ISSUE STATEMENT: PUBLIC HEARING AND POSSIBLE VOTE CONCERNING A PROPOSAL TO PAY A FEE IN LIEU OF STORMWATER DETENTION FOR IMPROVEMENTS AT 110 NORTH FORT STREET

DATE: NOVEMBER 4, 2024

SUBMITTED BY: DAVE BODEEN, P.E.

ALL THINGS NEW
 110 N. FORT ST.
 NIXA, MO 65714

1 GRADING PLAN
 C2 scale: 1" = 10'-0"

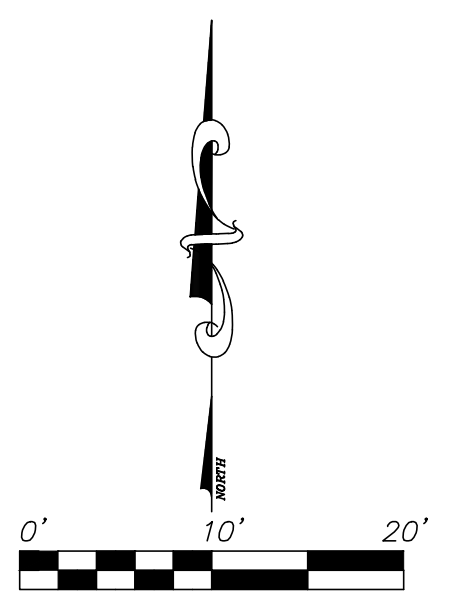
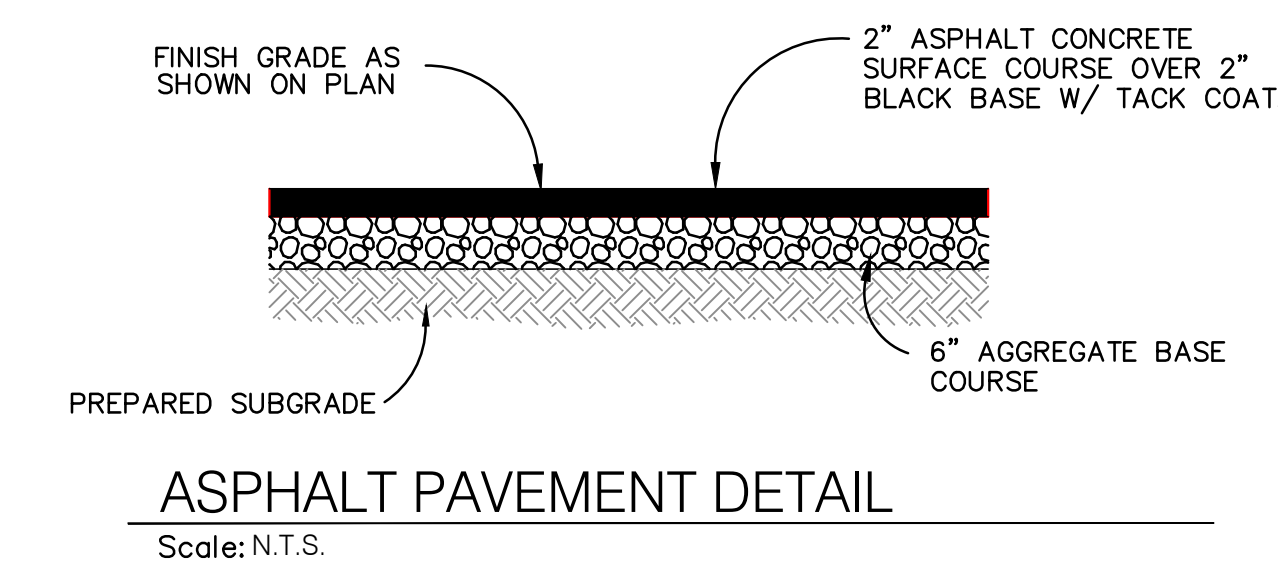
Stormwater runoff from the subject property will sheet flow to the east. The stormwater will end up on the same property that receives the discharge from AutoZone. The amount of impervious surface being added to the lot is less than what was previously there when the property in question was used for Lola's Pastries & Eatery. The developer will pay the city \$1,001 ($7150 \times .14 = 1,001$) that will be held until expended on stormwater improvements in this same drainage basin.

The proposed fee in lieu of detention, complies with Section 125(c)(2) of the Nixa Technical Specifications Manual. Staff recommend approval of this request.
